AGENDA

Planning Commission Meeting

July 20, 2021 | 6:30 p.m.

1. **Special Use Permit:** Request from Daniel Marquardt and Susan Schwichtenberg at 2554 Eastman Drive to build a new garage exceeding 624 square feet in size – PID 18-30-23-12-0028.

(PROPOSED GARAGE AND SHED CONFIGURATION – JUNE 2021)

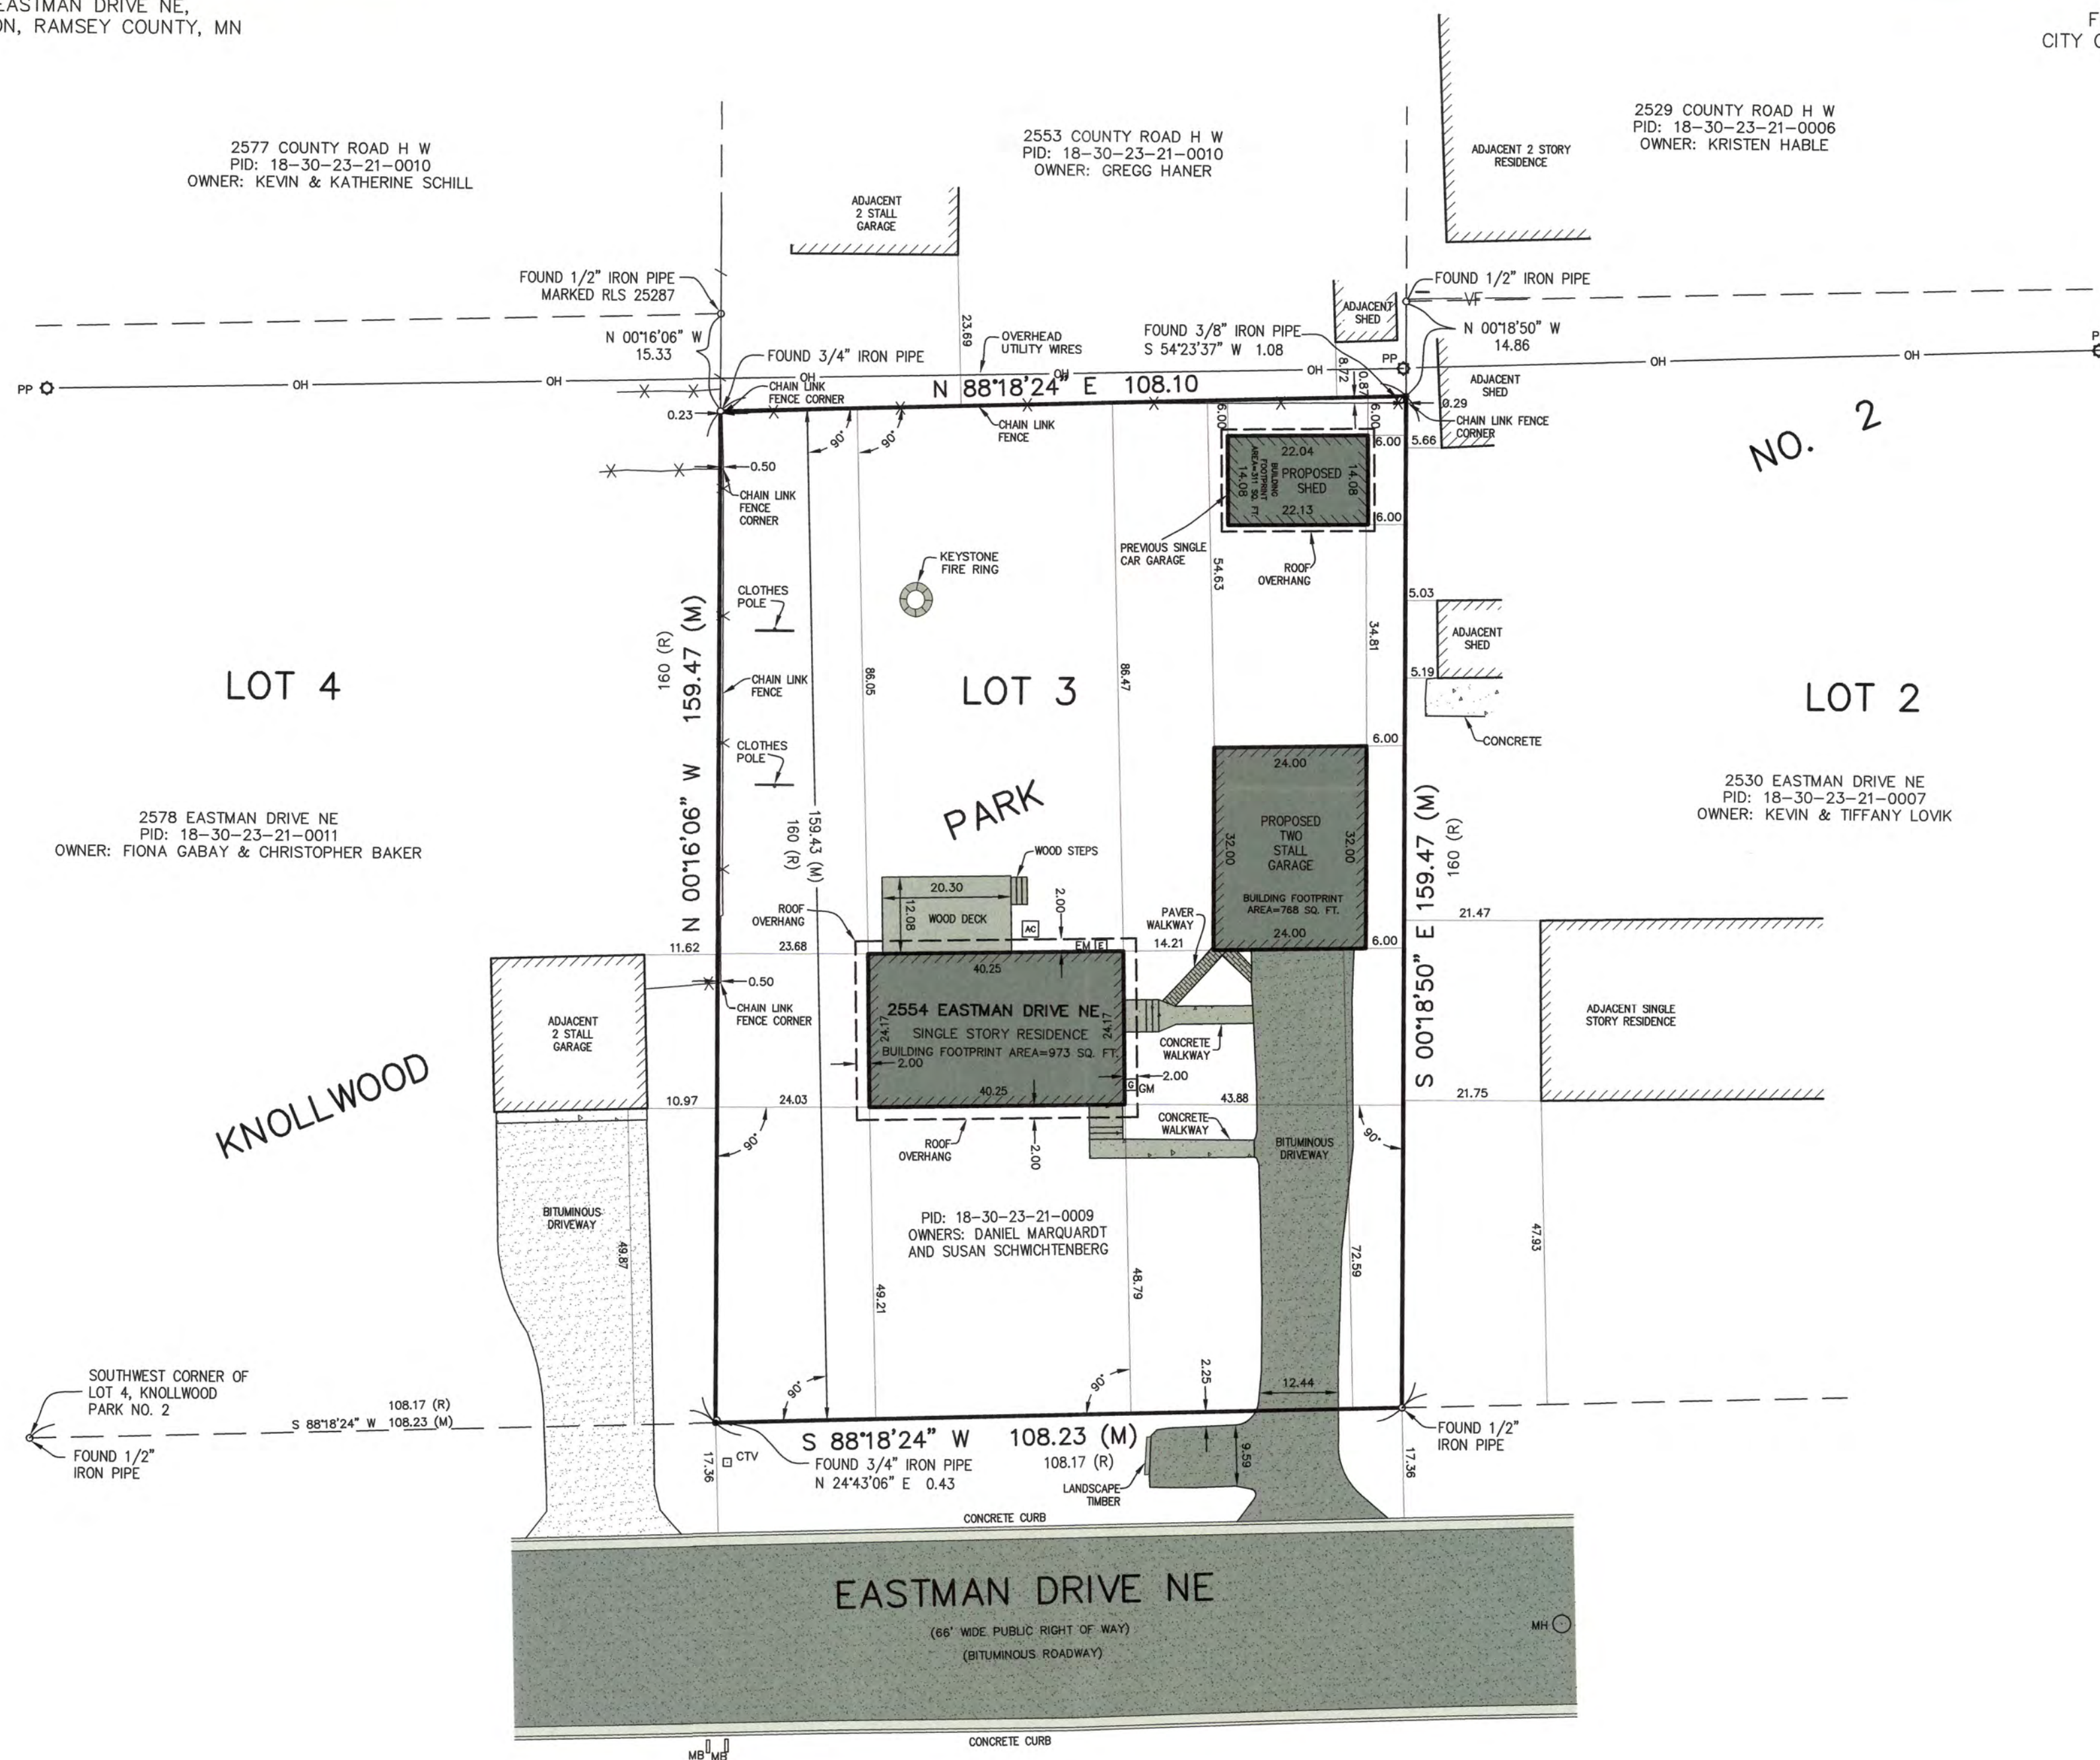
The Engineering Department has reviewed the site plan for the property at 2554 Eastman Drive and we offer the following comments:

- 1) Drainage patterns and existing utilities need to be verified and shown on plans to demonstrate that no adverse impacts will occur.

<p>Recommended Conditions:</p>	<ol style="list-style-type: none"> 1. The Special Use Permit shall authorize the location and size of garage as shown on the Certificate of Survey for 2554 Eastman Dr dated June 11, 2021; any changes to the location or size of the garage addition shall require an amendment to this permit. 2. Roof and exterior color and material(s) must be consistent and complimentary with the principal structure. 3. No commercial or home occupation activity shall be conducted within the detached garage. 4. Final building plans must show the resulting drainage patterns around the structures will not adversely impact neighboring properties. 5. Failure to adhere to conditions of approval shall be grounds for revocation of the special use permit by the City Council.

Figure 6. Google Earth image showing locations of barriers
North (19' tall x 255' long), South (17' tall x 350' long)
FXG New Brighton MN

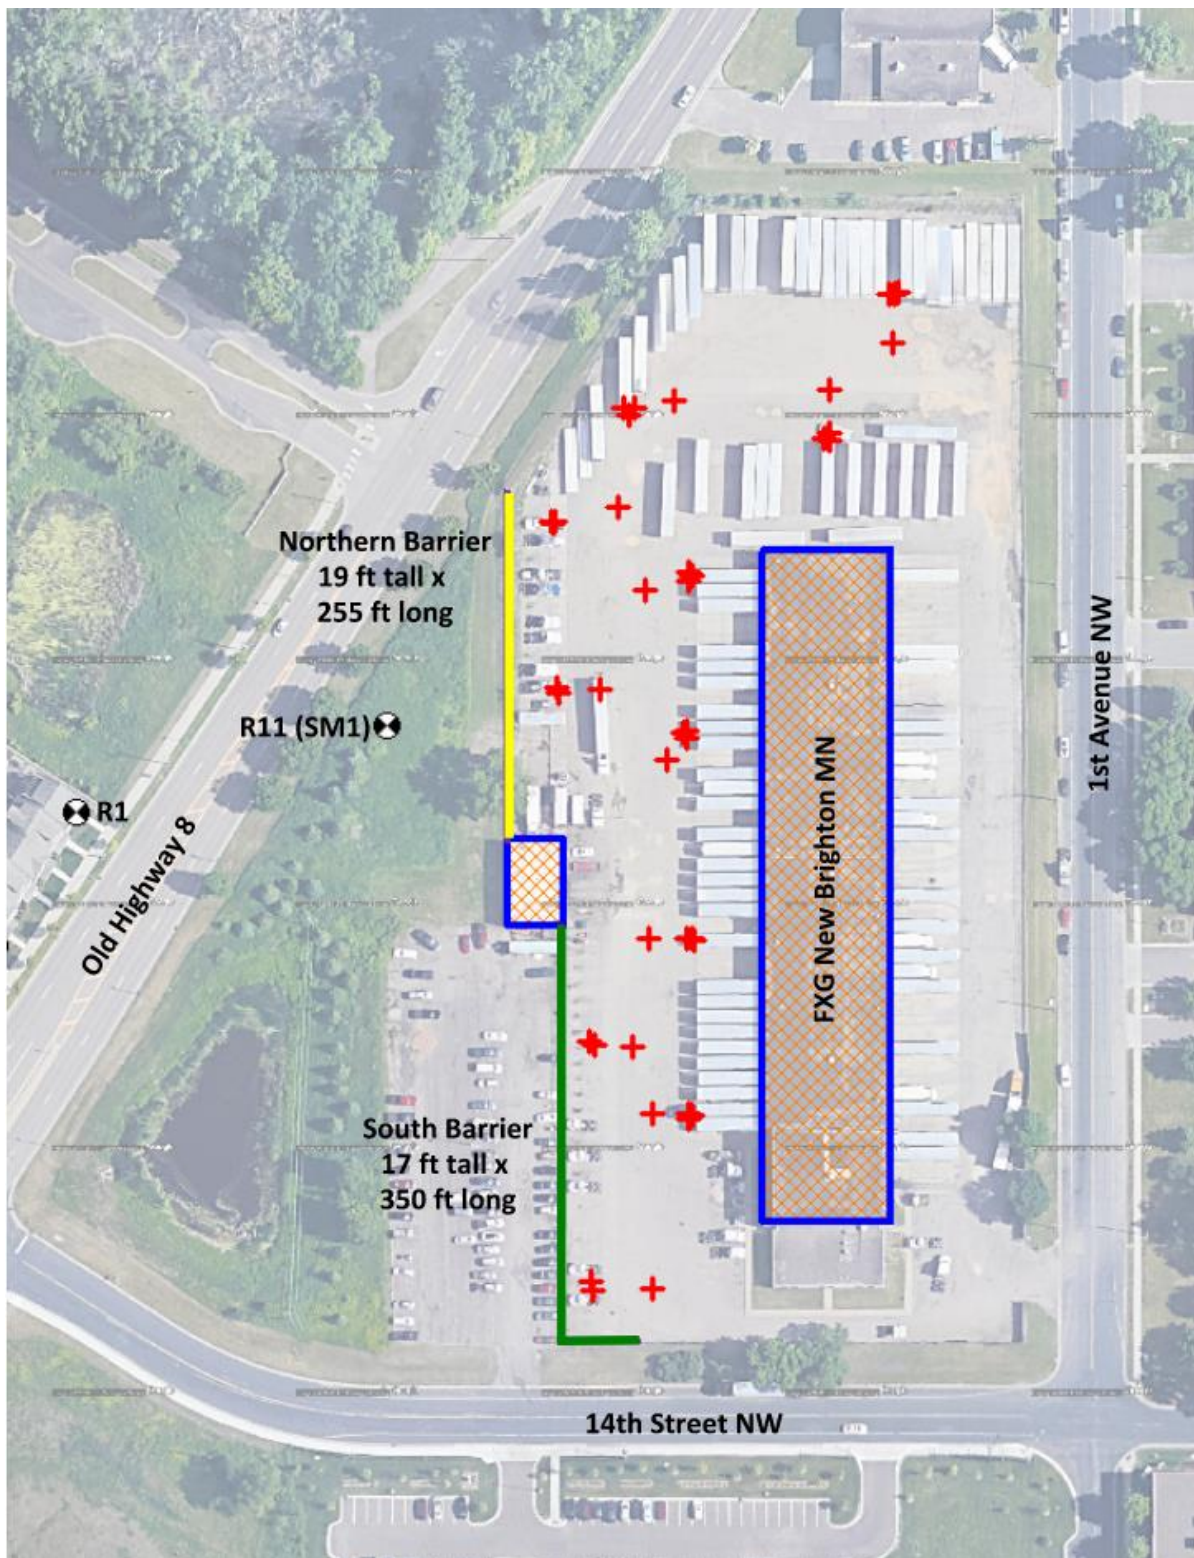
- 1) Existing utilities (private and public) need to be shown on plans. Additional details are needed where north wall crosses storm sewer and in the proximity to water services.
- 2) Additional information needed to demonstrate the wall(s) will not impact site drainage.

1. The Special Use Permit shall authorize a northern barrier which is 19' tall and approximately 255' long, and a southern barrier that is 17' tall and approximately 350' long.
2. Plans shall be updated to show existing utilities (private and public). Adjustments, if needed, shall be made to address any engineering concerns to protect utilities or to ensure proper drainage.
3. Additional minor adjustments to the fence location and length may be administratively approved by staff, but major adjustments shall only be authorized via an SUP amendment.
4. The sound barrier shall be properly maintained and in place while the legal nonconforming trucking use is in operation. Removal of the wall or failure to maintain the wall aesthetically or operationally will be deemed an illegal expansion of the legal nonconformity.
